SABIC Jubail New Building

Expert Joint Statement -Structural Engineering

20 November 2024

EXPERT JOINT STATEMENT – EXHIBIT A

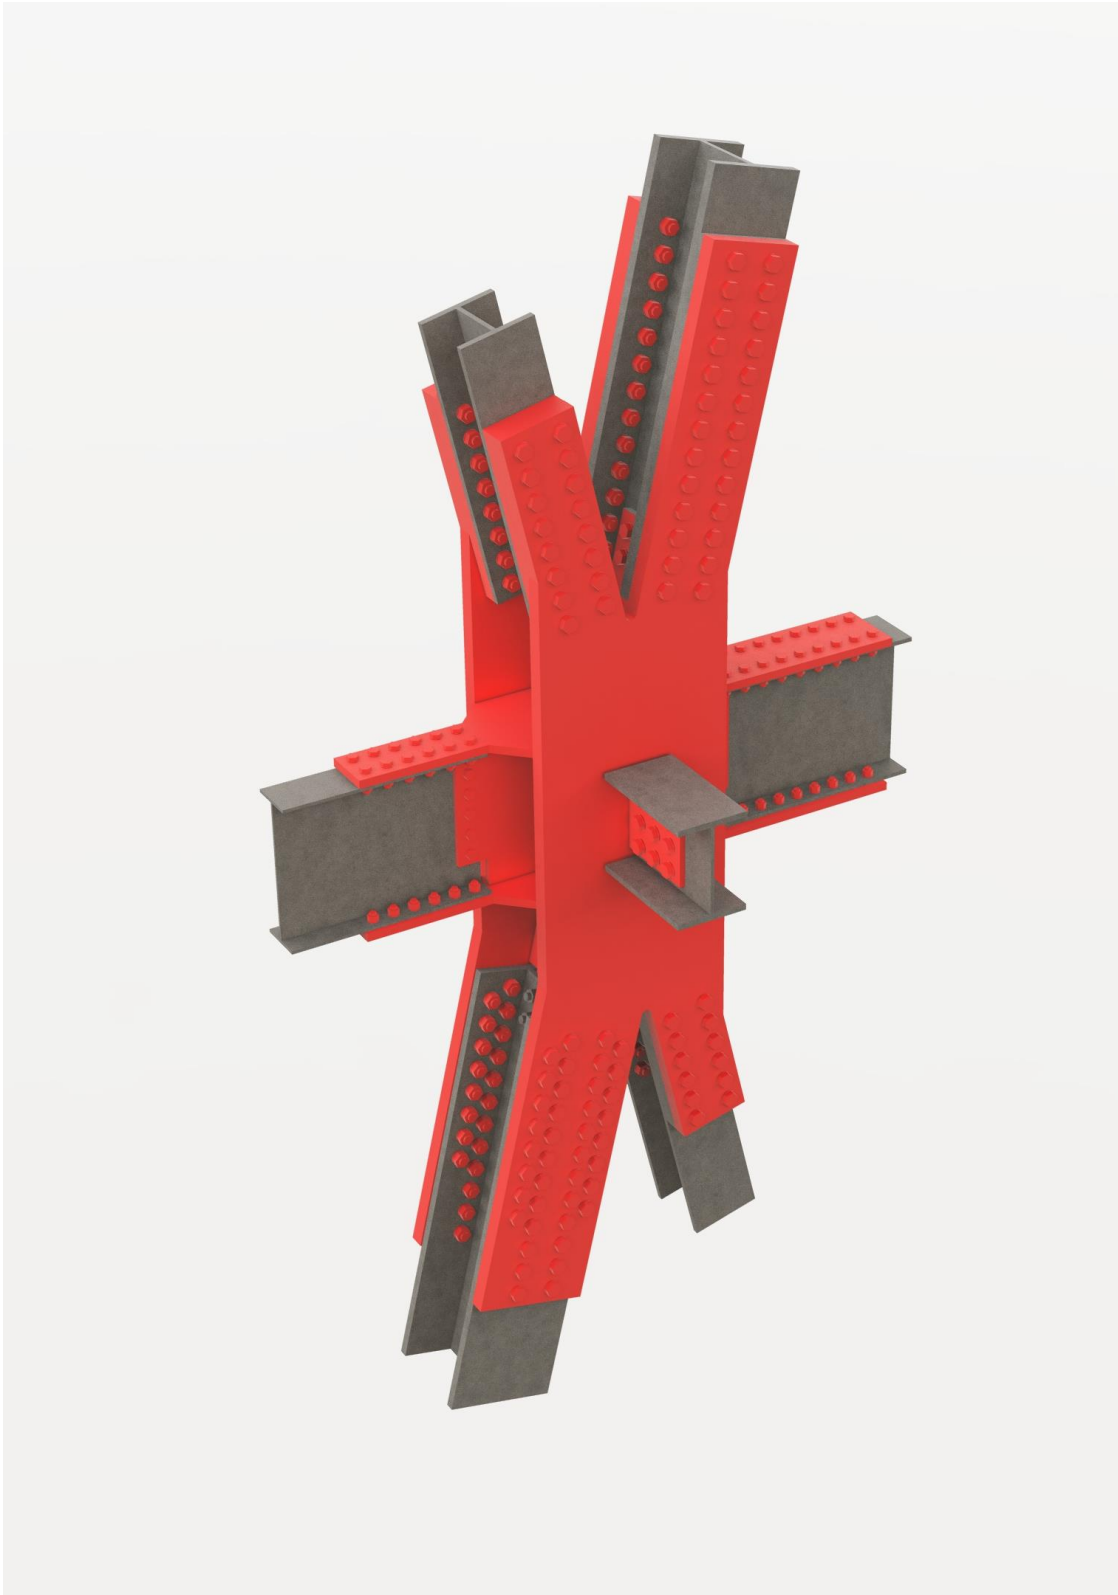
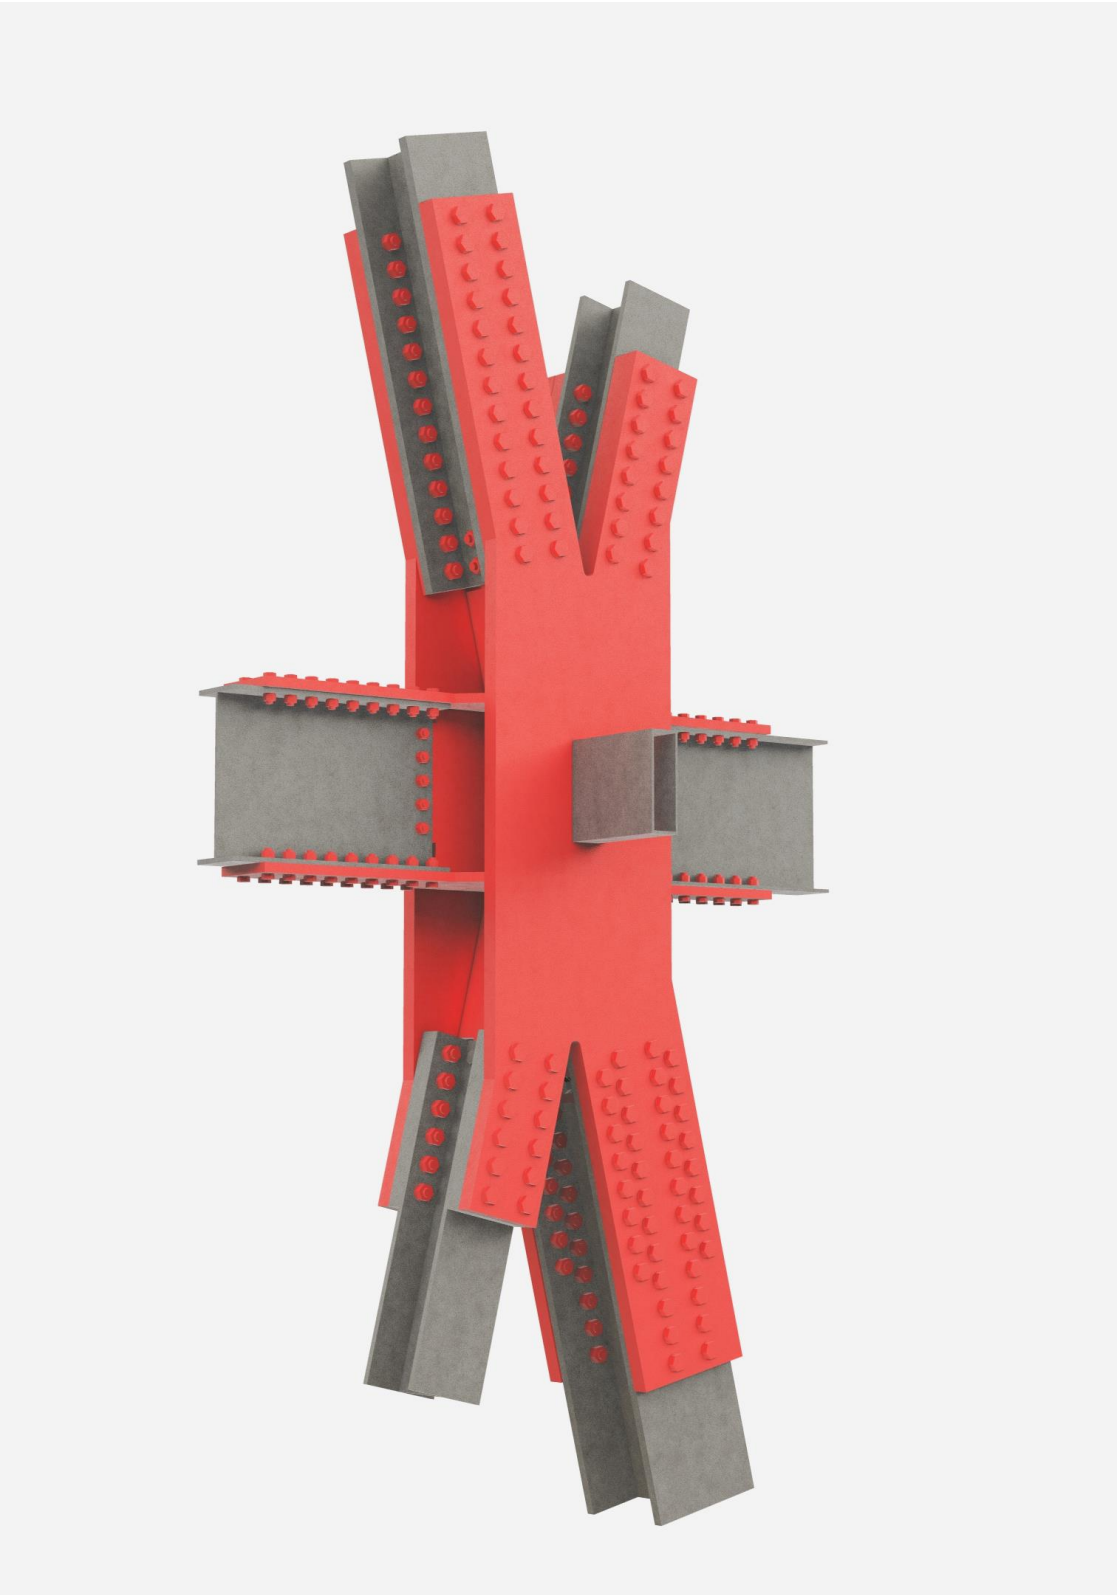
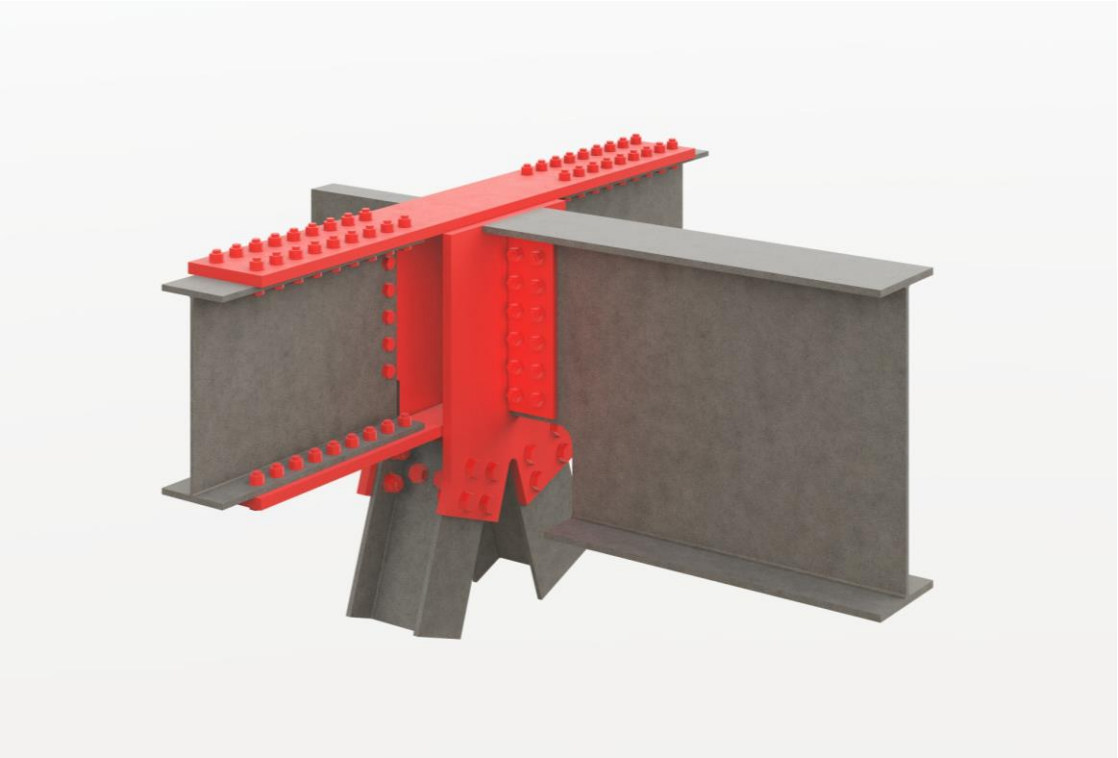
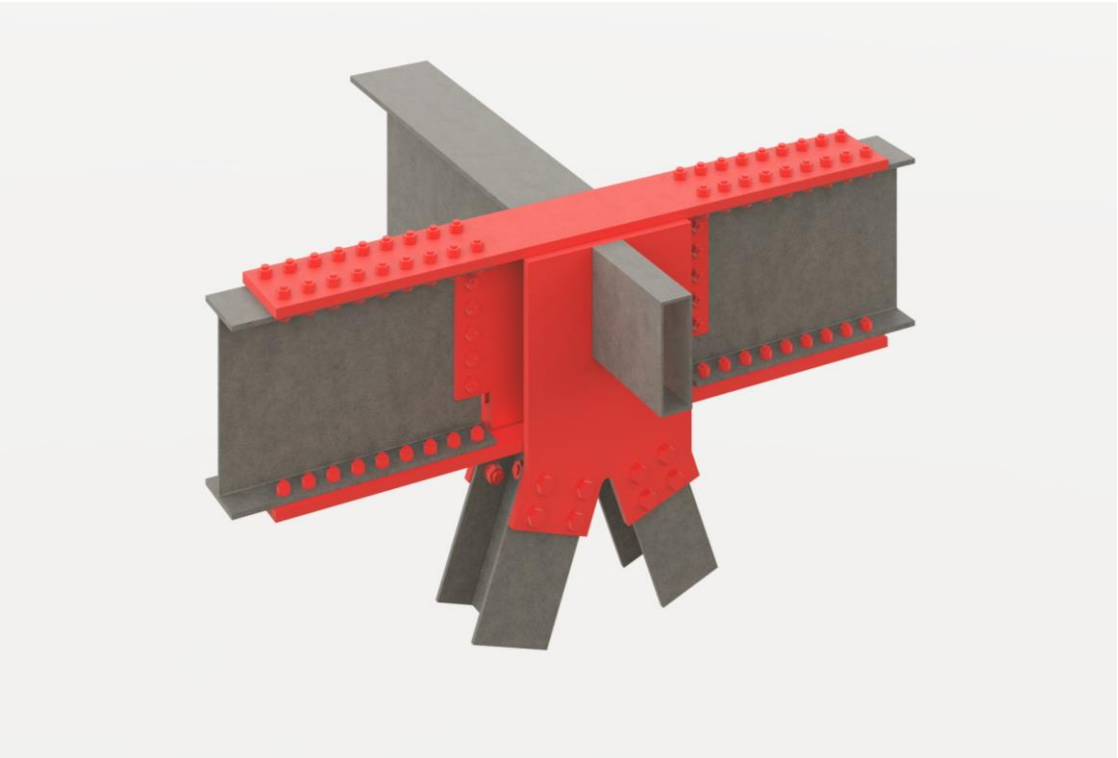
3.28	Were the connection details in the IFC drawings issued by TT, in the original tender, or subsequently, reasonably efficient by industry standards?	Not agreed	No, details were not efficient and too costly for the industrial standards. In some cases, they have proved being not applicable to real cases or buildable. Refer to the report AIC-016-FE-RP002_REV00. A comparison model providing a visual indication of the difference in the IFC model implemented on site	Yes – as evidenced by AIC willingness to proceed with the fabrication in accordance with the Rev. 1 details and the support and advice provided by TT post August 2018. I have raised my concerns regarding the inappropriate nature of the introduction of any new exhibits to

Item	Issue to be Discussed	Agreed?	Items Not Agreed and/or comments	
			Mr Magarotto's Views	Mr Burns' Views
			<p>and my design is attached to this report as exhibit A.</p> <p>Note to Mr. Burns side comment – The 2no. connections shown in Exhibit A in the right hand side of the pages and discussed in the report AIC-016-FE-RP002_REV00 are the final TT design from IFC drawings rev00 and rev01 which have been used under the instruction of SPML for fabrication and erection, and therefore implemented on site.</p> <p>For these cases, the welded alternatives were not compatible with the erection method and therefore were discarded.</p>	<p>this Joint Statement. I have asked Mr. Magarotto to identify where in any of Maffeis' 3 no. technical reports the diagrams included in exhibit A have been shown, but this has not been confirmed.</p> <p>I note the reference, “ in the model implemented on site...” in Mr. Magarotto's views – Maffeis' report ref. AIC-016-FE-RP002_REV00, paragraph 2 refers specifically to AFC drawings by TT revisions 00 and 01 and does not refer to as-built drawings, so it is not possible to confirm from the Maffeis reports if the details show in exhibit A are, in fact, implemented on site.</p> <p>It is important to note that the TT AFC (IFC) drawings rev. 00 included alternative connection details for welded, rather than bolted connections – these alternative details appear to have been disregarded both in Maffeis' original reports and in exhibit A.</p> <p>I note Mr Magarotto's comment regarding compatibility of TT's welded connection alternatives – I have not seen any evidence to confirm this statement.</p>

Reference to Table 1, items 2.4 - 2.7 - 3.28
